FINAL PRODUCT/PROCESS CHANGE NOTIFICATION #16642

Issue Date: 31-May-2011**TITLE:** Final Notification for Qualification of SOT23 3L, SOT23 5L & SOT23 6L Packages in Assembly and Test Site in LPS (China).**PROPOSED FIRST SHIP DATE:** 31-Aug-2011**AFFECTED CHANGE CATEGORY(S):** Package, Device Marking, Date Code Marking, Pin Configuration, Assembly & Test Site**FOR ANY QUESTIONS CONCERNING THIS NOTIFICATION:**Contact your local ON Semiconductor Sales Office or <SueiHuey.Wong@onsemi.com>**SAMPLES:** Contact your local ON Semiconductor Sales Office**ADDITIONAL RELIABILITY DATA:** AvailableContact your local ON Semiconductor Sales Office or <francis.lualhati@onsemi.com>**NOTIFICATION TYPE:**

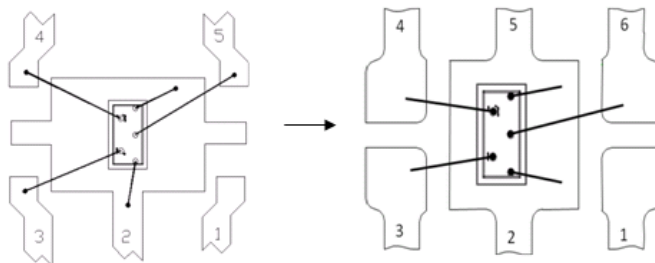
Package Change & Pin Configuration Change: The package for SOT23 5L devices will change to SC-74. Pin 5 will be replaced by Pin 6 of SC-74. Pin 5 of the SC-74 will be the same electrical connection as Pin 2.

Device Marking Change: The marking for all affected devices will change from 4 characters to 3 characters with the first character being removed.

Date Code Marking Change: The date code marking will be changed from YYWW to one digit/alphabet monthly date coding on the device top side.
